Originator's
Files OZ 07/013 W2

DATE: September 15, 2009

SUBJECT: **Official Plan Amendment and Rezoning Applications**
To permit the redevelopment of the lands, including an 8 storey
retirement dwelling, convenience restaurant and
two commercial buildings
1829 and 1865 Lakeshore Road West
North side of Lakeshore Road West,
west of Clarkson Road North
Owner: RioCan (Clarkson) Inc. and McDonald's Restaurants
of Canada Limited
Applicant: Glen Schnarr and Associates Inc.
Bill 51

Supplementary Report **Ward 2**

Building Elevations

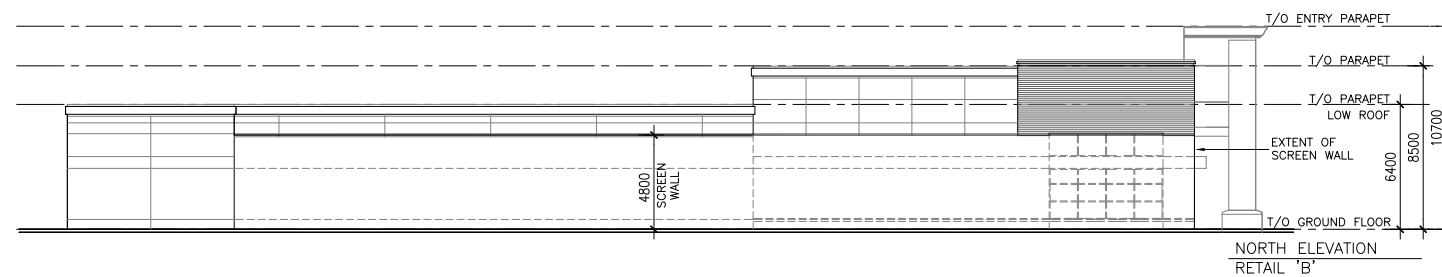
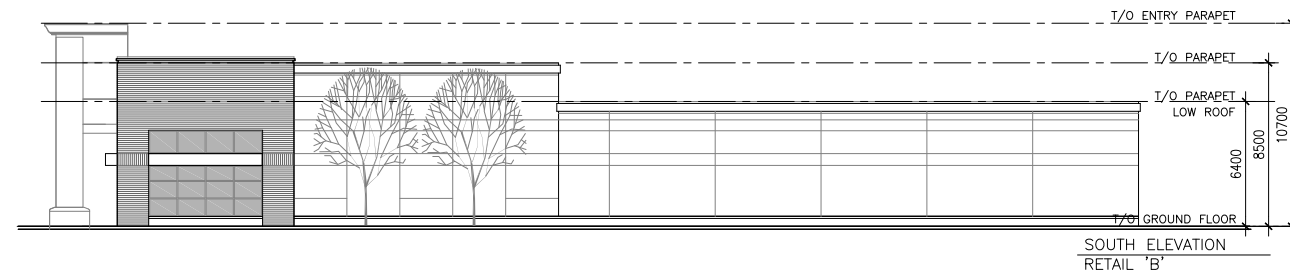
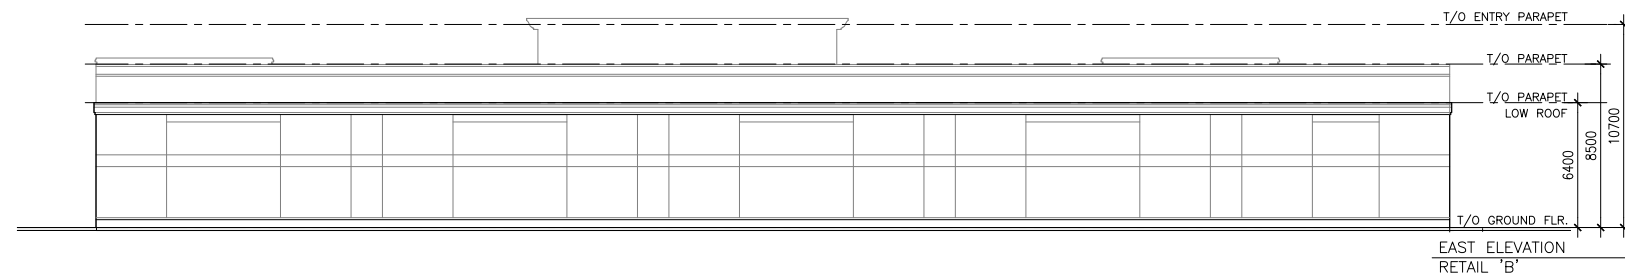
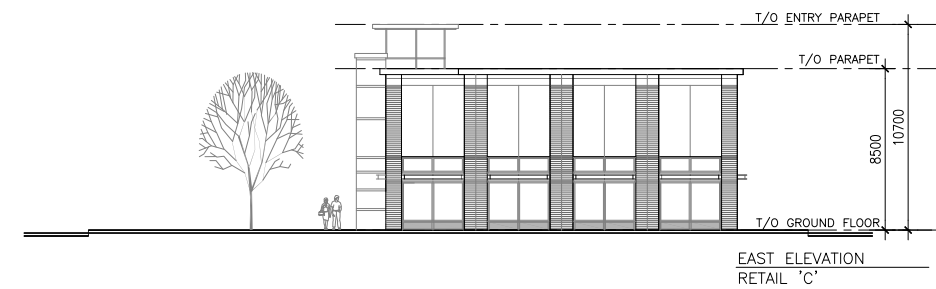
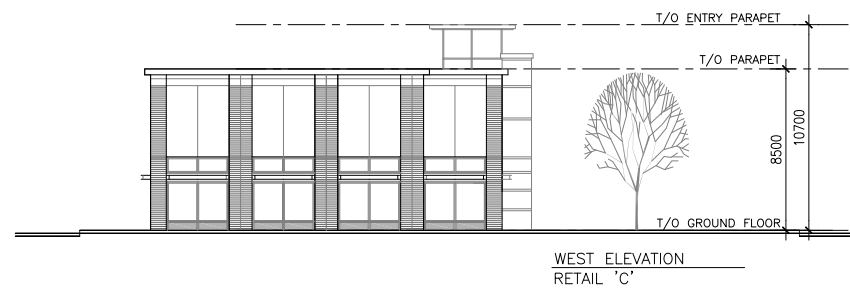
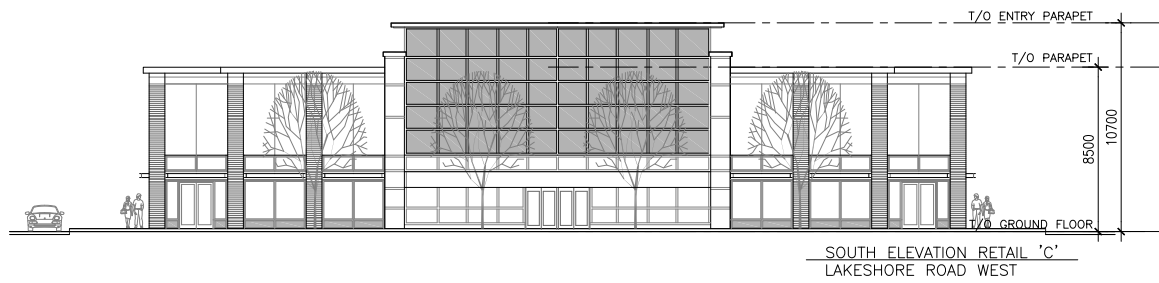
With respect to the proposed HomeSense store (Building 'B'), given its proximity to residential to the rear, it is recommended that maximum building heights be required in accordance with the elevation drawing heights shown on Appendix S-5 Page 3, being 10.7 m (35 ft.) at the building front, 8.5 m (27.8 ft.) in the middle section and 6.4 m (21 ft.) at the rear of the building.

- Minimum building height of 7.5 m (24.6 ft.) or 2 storeys for a convenience restaurant.
- Minimum building height of 1 storey for the HomeSense store with maximum building heights of 10.7 m (35 ft.) at the building front, 8.5 m (27.8 ft.) in the middle section and 6.4 m (21 ft.) at the rear of the building, in accordance with the elevation drawing heights shown on Appendix S-5 Page 3 of this report.
